FPP RMA Report

Draft Pricing Review Determination for Chorus' Unbundled Copper Local Loop Service

10 February 2015

Figure 1: Length of Lead-In Cable, Source: Model Specification Document, TERA Consultants

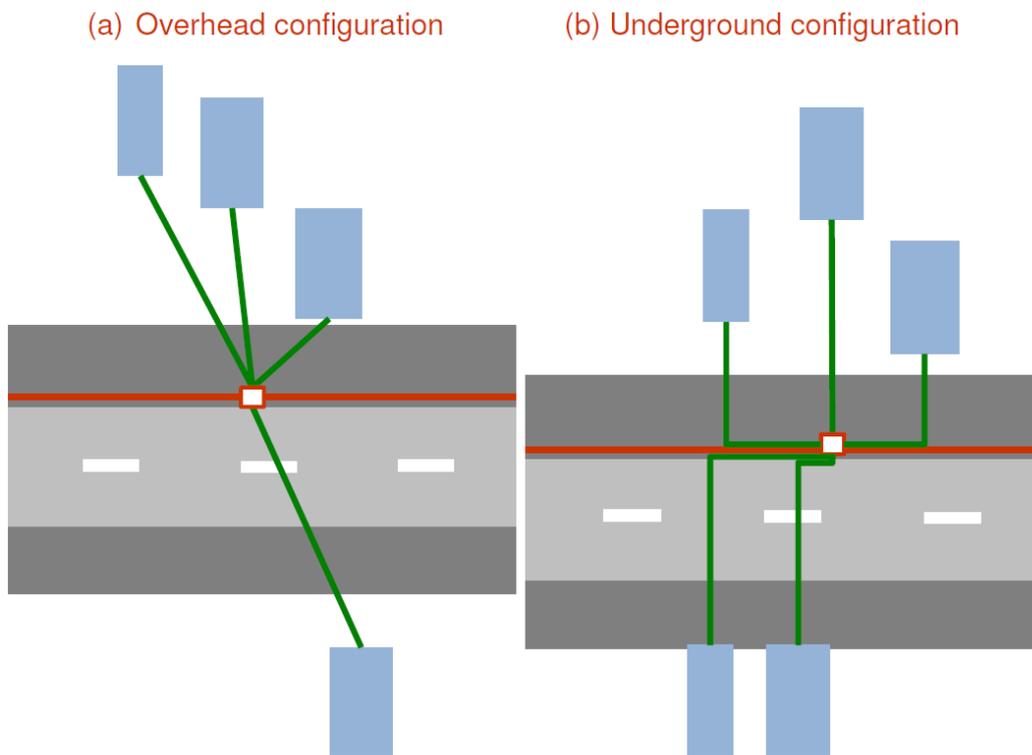
As set out in Section 1.5.1 Modelling Approach of the TERA Model Specification⁶, the path to be followed by the cable connecting any dwelling to a network aggregation point is the shortest path, to ensure optimisation of the network length in order to ensure best quality of service. The method of connecting a customer on the opposite side of the road to the distribution cable by the shortest path is demonstrated schematically in Figure 26 – *Length of lead-in cable* of the Model Specification (see Figure 1 below).

Experience with the Chorus suite of UFB resource consents is that the existing network architecture often does not follow this shortest distance approach. Where aerial deployment has occurred, electricity and Chorus lines generally cross the road to connect to a Chorus service pole on the opposite side, before redistributing to customer premises, often via multiple lead-in spans between service poles along the opposite side of the road. Incite’s observations on site visits during the consent process is that a direct connection across a road to a customer premises on the opposite side (without first connecting to a Chorus service pole) is not the typical deployment scenario. Further, in many instances, there are no ‘direct’ road crossings of lines between an EDB pole and Chorus pole immediately on the opposite side, so there is often no existing road crossing to follow across the road to ensure the shortest possible connection distance to a customer (e.g. the customer

lead-in may need to run along several spans to connect to a customer on the opposite side of the road).

Figure 2: Rule 2.1 and Rule 3.2 of the Chorus Consenting Rule Book demonstrating situations where Chorus cannot deploy new road crossing or customer connection lines.

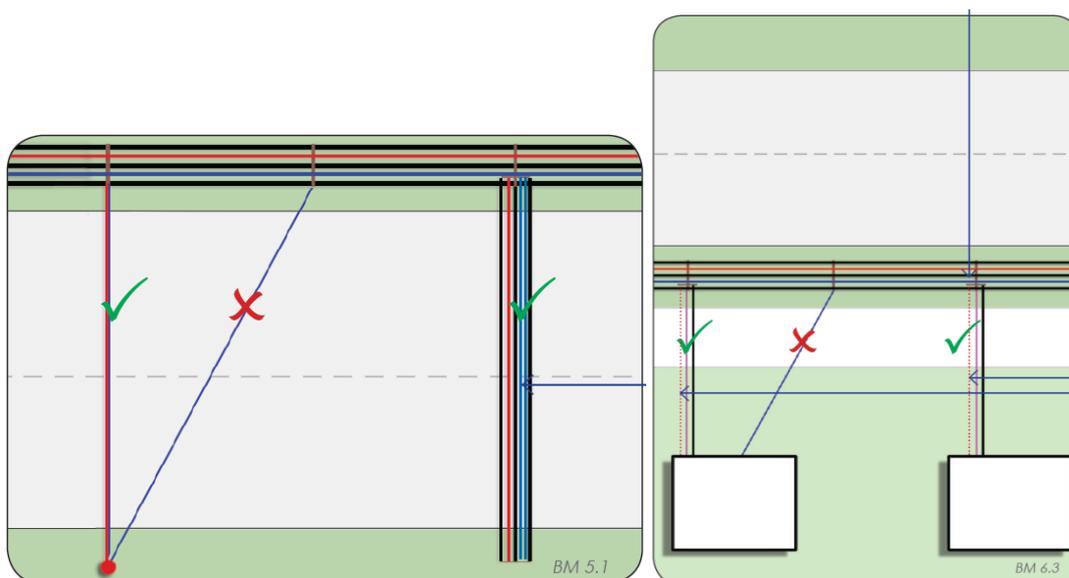
The detailed deployment rules for road crossings for Chorus’ Standard Methodology are set out on Sheet 5 of the Consenting Rule Book in **Appendix A**. A key plank of the methodology developed and subsequent visual assessments and resource consents was to reduce visual impact by not creating any new road crossings. Therefore, the network modelled by TERA of simply connecting customers across a road by the shortest route will, in a significant number of situations, fall outside of the Chorus suite of resource consents, and may be difficult for another HNO to gain consent for. Where an existing road crossing cannot be followed, the Chorus resource consents would require underground deployment unless a separate resource consent for that work could be obtained (noting that in some areas resource consents are not required for aerial deployment, so these restrictions on deployment may not apply – see Table 1 above). The road crossing restrictions in the Standard Methodology apply to the resource consents granted for all of Auckland Council area, Hutt City, Gisborne City and the certificates of compliance granted for Wellington City customer connections, and Levin. They do not apply to Porirua City.

Figure 3: Location of Poles, Source: Model Specification Document, TERA Consultants

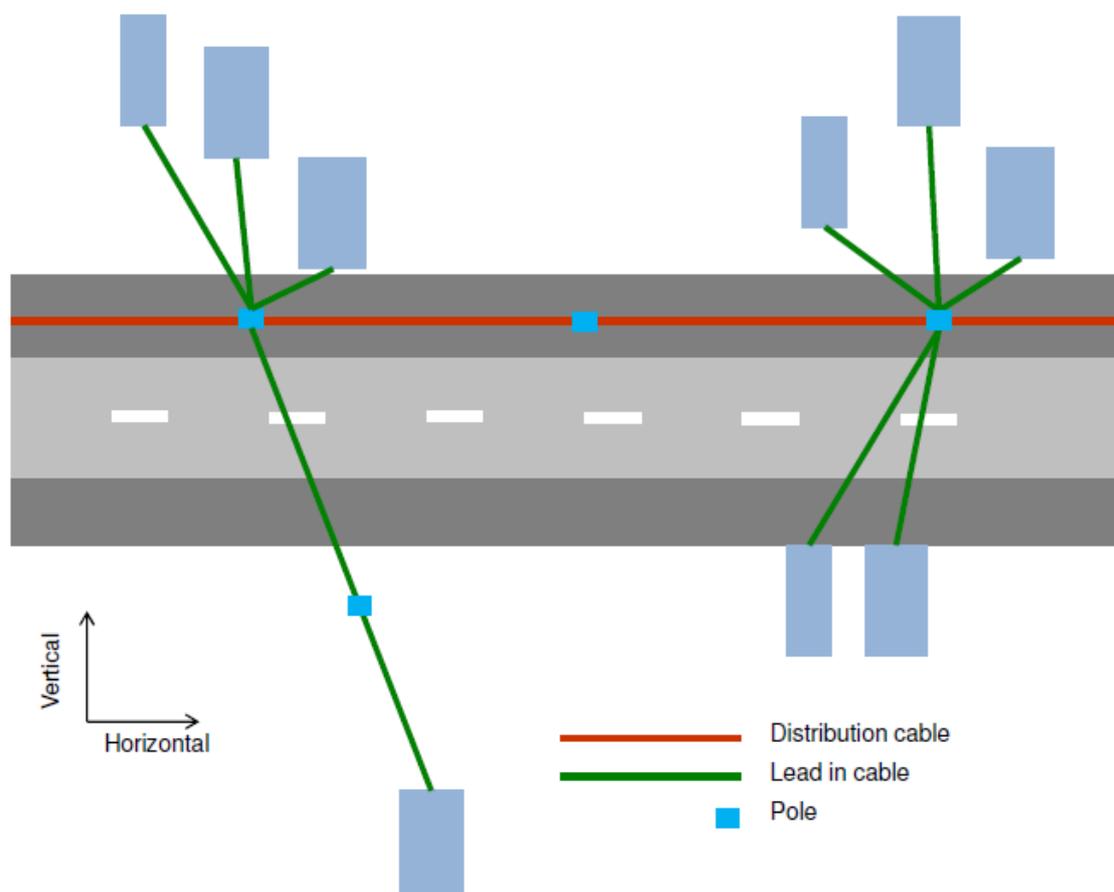
The Chorus Standard Methodology also does not allow for any new poles to be installed in association with the service connection to a customer. However, the TERA methodology assumes a pole or poles will be installed where the lead-in cable (from the distribution cable side to the customer premises ETP across the road, exceeds the maximum distance between poles that is allowed for in the model. This is shown schematically in *Figure 28 – Location of poles* of the Model Specification (see Figure 3).

The Chorus Standard Methodology does not allow for these additional poles to be erected in association with customer connections (there are exceptions in some of the certificates of compliance granted such as customer connections in Porirua City where one new pole is allowed to facilitate a customer connection).
